# Access Compliance Report

## Public Rights-of-Way

### (Pedestrian Signals)

Intersection ID: N/A	Main Street:	Cross Street: N/A	Location: N/A
ADA ID: D233003595B4	Signal Type: Two Push Buttons-Non APS	Overall Compliance: No	Severity Score: BTN 1:N/A BTN 2: N/A No BTN: N/A
Codes/Mitigation Info/Possible Solution		Field Measurements/Component Compliance

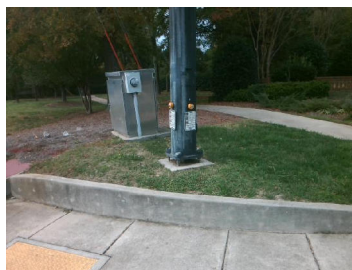
Compliance	Description	Data	Compliance	Description	Data
	Button Count	Button2	N/A	Distant to Additional Button (in)	N/A
	Additional Button Present?	No		Additional Button ID	N/A
N/A	Signal Buttons Required?	N/A	N/A	Additional Ped Posts Required	N/A
	How Many Ped Street Xings?	2		Located In An Island/Median?	No
N/A	B 1 Sign Present?	Yes	N/A	B 2 Sign Present?	Yes
Yes	B 1 Sign Purpose?	Yes	Yes	B 2 Sign Purpose?	Yes
Yes	B 1 Sign Lettering & Contrast?	Yes	Yes	B 2 Sign Lettering & Contrast?	Yes
Yes	B 1 Parallel To XWalk?	Yes	Yes	B 2 Parallel To XWalk?	Yes
Yes	B 1 PAR to Button?	Yes	Yes	B 2 PAR to Button?	Yes
Yes	B 1 PAR to XWalk?	Yes	Yes	B 2 PAR to XWalk?	Yes
No	B 1 Clear Floor Space?	No	No	B 2 Clear Floor Space?	No
No	B 1 FWD Approach?	No	No	B 2 FWD Approach?	No
N/A	B 1 FWD Approach Constrained?	N/A	N/A	B 2 FWD Approach Constrained?	N/A
N/A	B 1 FWD Approach Reach (in)	N/A	N/A	B 2 FWD Approach Reach (in)	N/A
N/A	B 1 FWD Approach Width (in)	N/A	N/A	B 2 FWD Approach Width (in)	N/A

N/A	B 1 FWD Approach Obstruction?	N/A	N/A	B 2 FWD Approach Obstruction?	N/A
N/A	B 1 FWD Approach Obstruction Dist (in)	N/A	N/A	B 2 FWD Approach ObstructionDist (in)	N/A
No	B 1 PARA Approach?	No	No	B 2 PARA Approach?	No
N/A	B 1 PARA Approach Constrained?	N/A	N/A	B 2 PARA Approach Constrained?	N/A
N/A	B 1 PARA Approach Reach (in)	N/A	N/A	B 2 PARA Approach Reach (in)	N/A
N/A	B 1 PARA Approach Width (in)	N/A	N/A	B 2 PARA Approach Width (in)	N/A
N/A	B 1 PARA Approach Obstruction?	N/A	N/A	B 2 PARA Approach Obstruction?	N/A
N/A	B 1 PARA Approach Obstruction Dist (in)	N/A	N/A	B 2 PARA Approach ObstructionDist (in)	N/A
N/A	B 1 Clear Floor Space Slope (%)	N/A	N/A	B 2 Clear Floor Space Slope (%)	N/A
N/A	B 1 Clear Floor Space XSlope (%)	N/A	N/A	B 2 Clear Floor Space XSlope (%)	N/A
N/A	B 1 PAR Slope (%)	0.7	N/A	B 2 PAR Slope (%)	3.2
No	B 1 Height (in)	54.0	No	B 2 Height (in)	55.0
Yes	B 1 Pressure (#)	2.0	Yes	B 2 Pressure (#)	2.0

Yes	B 1 Clear Xing Direction?	ClearlyMarked	Yes	B 2 Clear Xing Direction?	ClearlyMarked
	B 1 Crossing Direction	To SE		B 2 Crossing Direction	To NE
Yes	B 1 DistanceTo XWalk (in)	0.0	Yes	B 2 DistanceTo XWalk (in)	0.0
No	B 1 DistanceTo Curb (in)	129.0	No	B 2 DistanceTo Curb (in)	163.0
Yes	B 1 Diameter (in)	2.0	No	B 2 Diameter (in)	2.0

Possible Solutions: Replace Signal Push Button With APS Button on New Post. Remove & Relocate Sign.
